Product Change Notification

Change Notification #: PCN 114616-00
Change Title: Intel® Compute Module HNS2600KPR and Intel® Compute Module HNS2600TPR PCN 114616-00
Product Design, Change to Node Tray Assembly and IOM Blank Filler
Date of Publication: May 26, 2016

Node Tray and IOM Blank Filler changes to support new capabilities.

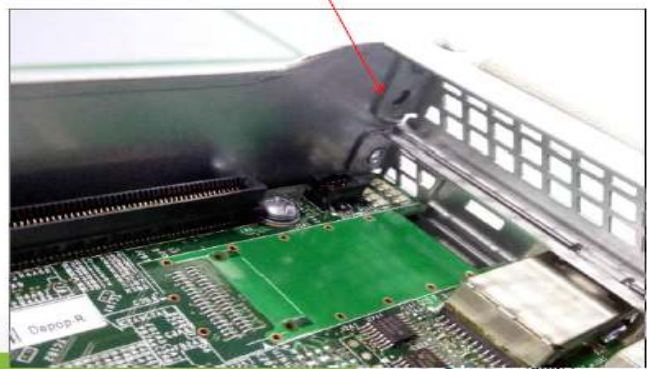
1. Two holes were added to the IOM Blank Filler to support M.2 Carrier: a rectangular hole to the left side of the Filler and a round hole on the inside right hand of the Filler. The pictures below illustrate these changes.

Square hole.

Round hole.

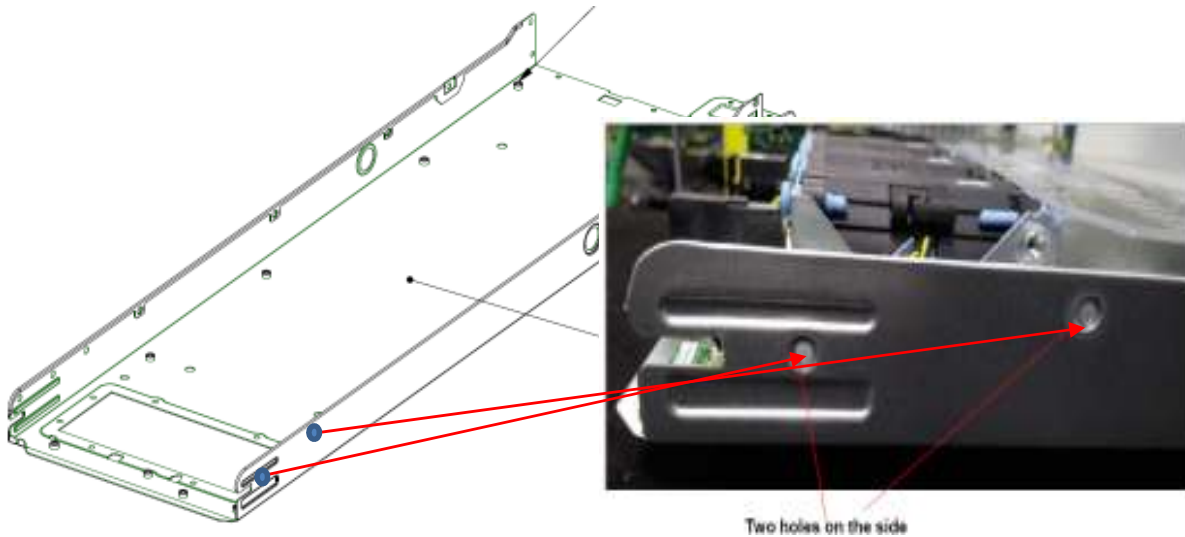
- Two holes are added to the front left side of the Node Tray to support NVDIMM supercar. Changes are marked in blue on the left picture and the final change is depicted on the right picture
